20181758 – BL419 – Psychology – AHU-7 Humidifier Modifications
Addendum 1

November 18, 2025

BL419 Psychology – AHU-7 Humidifier Modifications
Indiana University Bloomington
IU 20181758

1 PENTHOUSE MECHANICAL DEMOLITION PLAN
 1/4" = 1'-0"

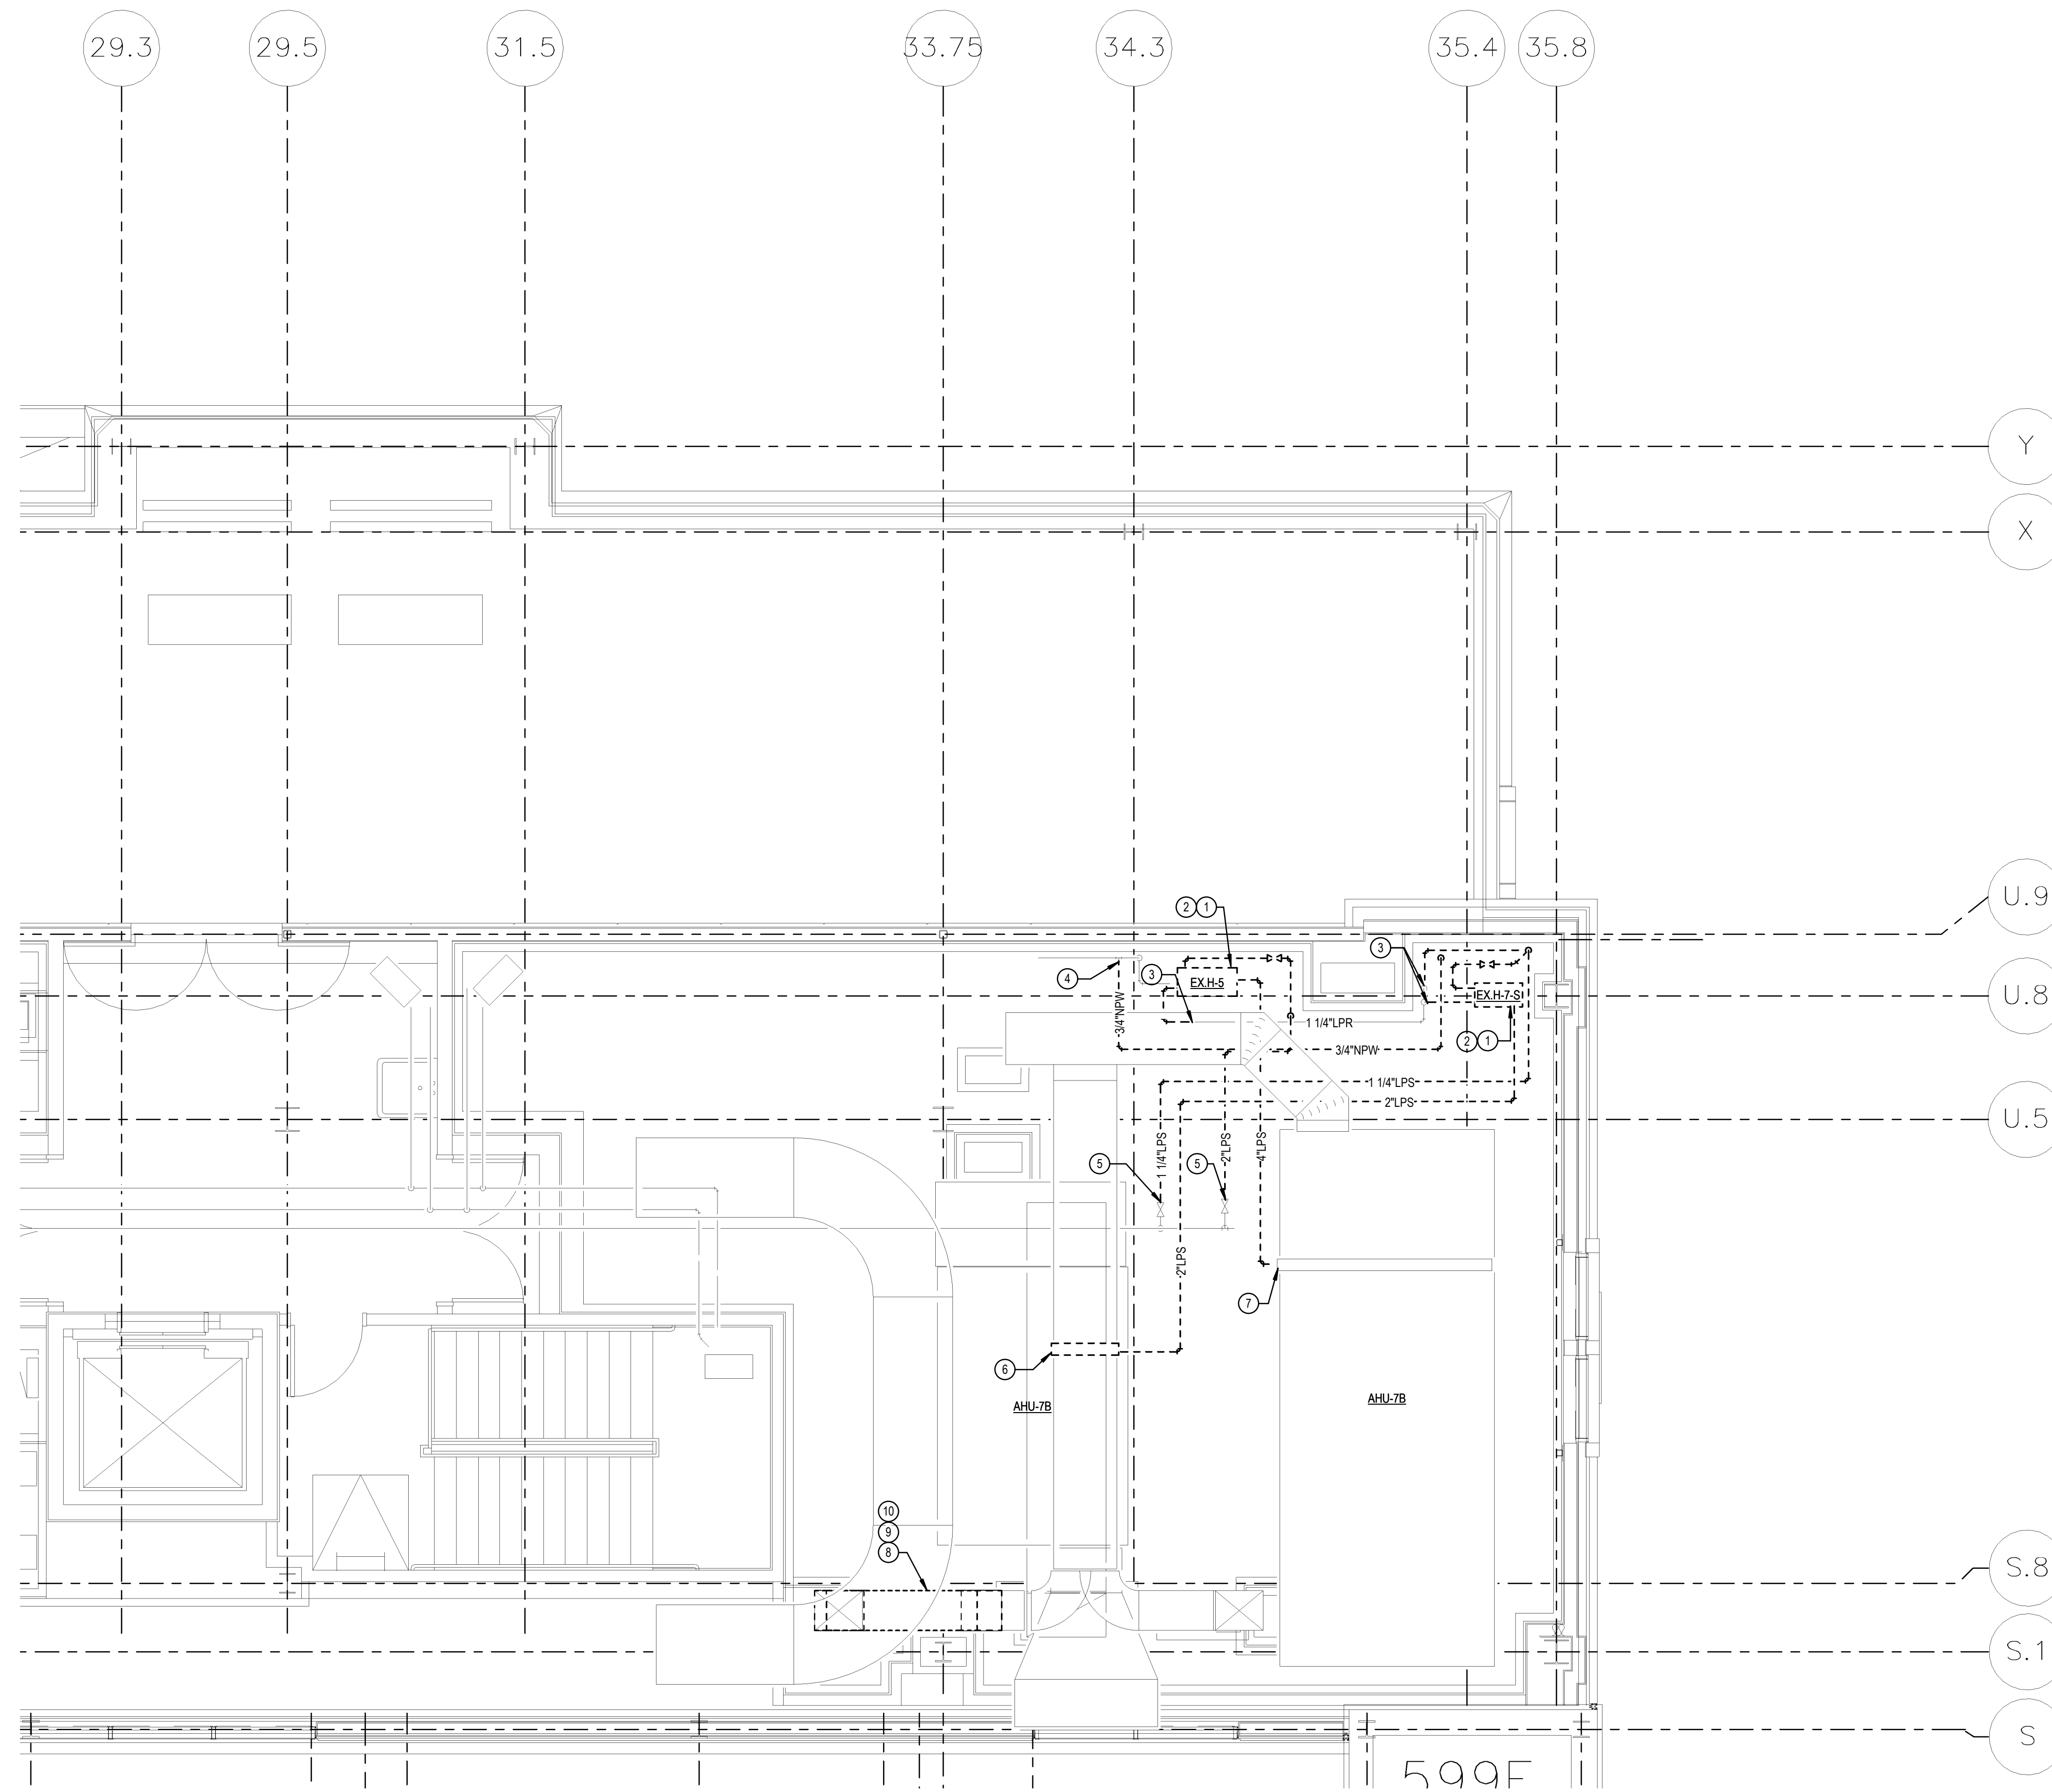
Modify the attached drawings below as indicated in the clouded areas.

1. Sheet M102 – Penthouse Mechanical Demolition Plan
2. Sheet M202 – Penthouse Mechanical Plan
3. Sheet M501 – Mechanical Details
